Revised Drawings for AES Wastewater Designs

You can view the full list of editable PDFs on our website at www.et.nz/technical-drawings. The five revised drawings are below and Harry's notes on the revisions follow.

AES VD - AES Bed, Distribution Box, and Septic Tank Air Venting Detail

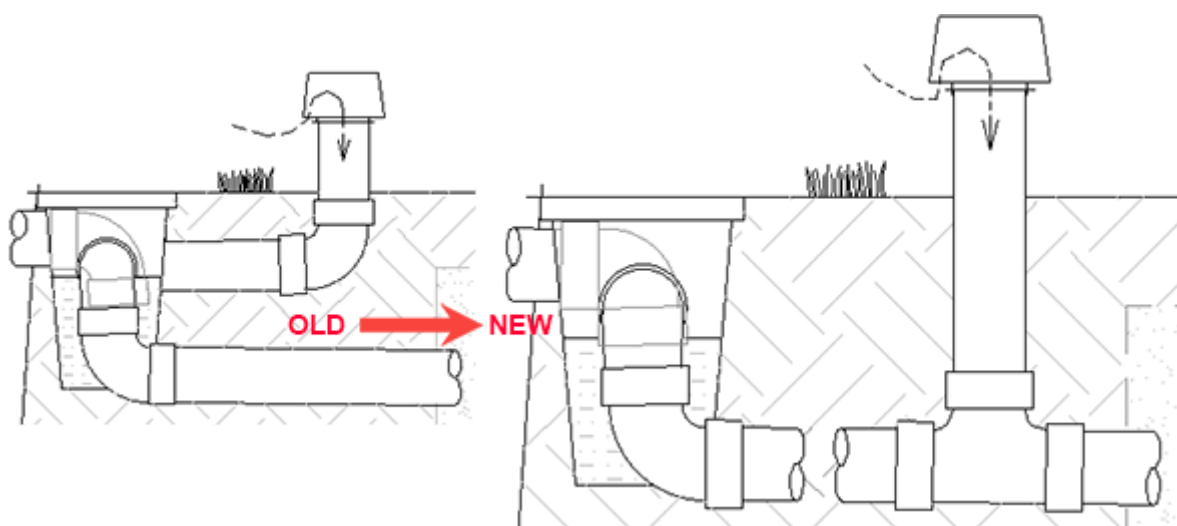
- Added a cross sectional view of the distribution box to indicate that the down-turned 88 degree bend forms a water trap. This then avoids the possibility of odour drawdown from the septic tank and related pipework. It also avoids the possibility of the passive venting of the AES bed being adversely affected by having alternative routes for air passage. Capping the septic tank outlet tee further guarantees the avoidance of the above.
- Changed the recommended positioning of the low level air inlet vent to be connected to the effluent inlet pipe of each subsystem of AES pipes instead of only being connected to the distribution box. If the low level air inlet vent is only attached to the distribution box air flow is then reduced to the 50mm diameter hole in the speed leveler, considerably reducing air flow.
